Date: Jul 19, 2021
Project: Administration Building Standby Generator Upgrade
Project Number: 21-030
Regarding: Addendum 1
Building Dept: Township of Oro Medonte
Distribution: Justin Metras (Oro Medonte)

Addendum #1

Figure 1: Extension Cord Layout

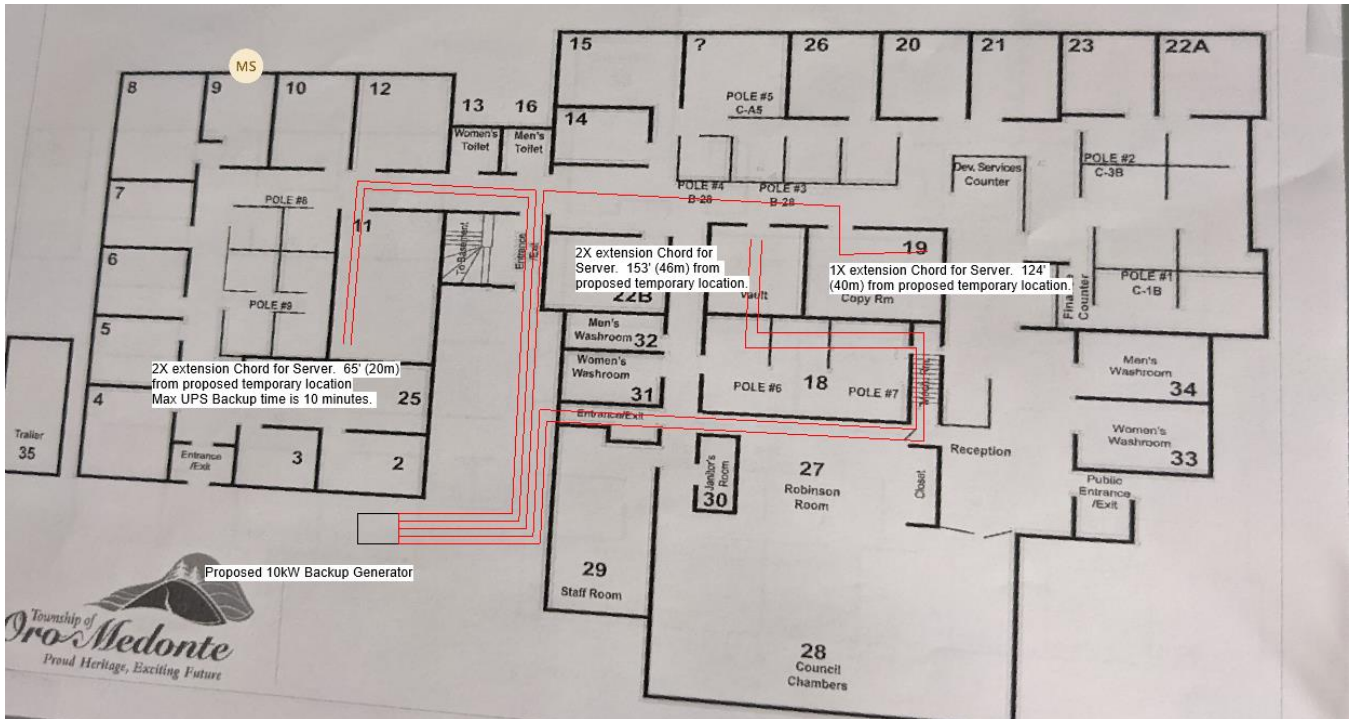
Q8: What are the expectations for shutdowns? Are there any highly sensitive loads that need to be backed up during outages?

A8: All shutdowns are to be less than 4 hours in duration and will need to be coordinated outside of the townships regular business hours. All shutdowns longer than 5 minutes, require a portable temporary inverter generator for the sensitive IT load outlined in Figure 1: Extension Cord Layout below. The portable inverter generator should be 6.5kW or larger and capable of supporting five (5) 15A, 120V Circuits. Provide extension cords as required.
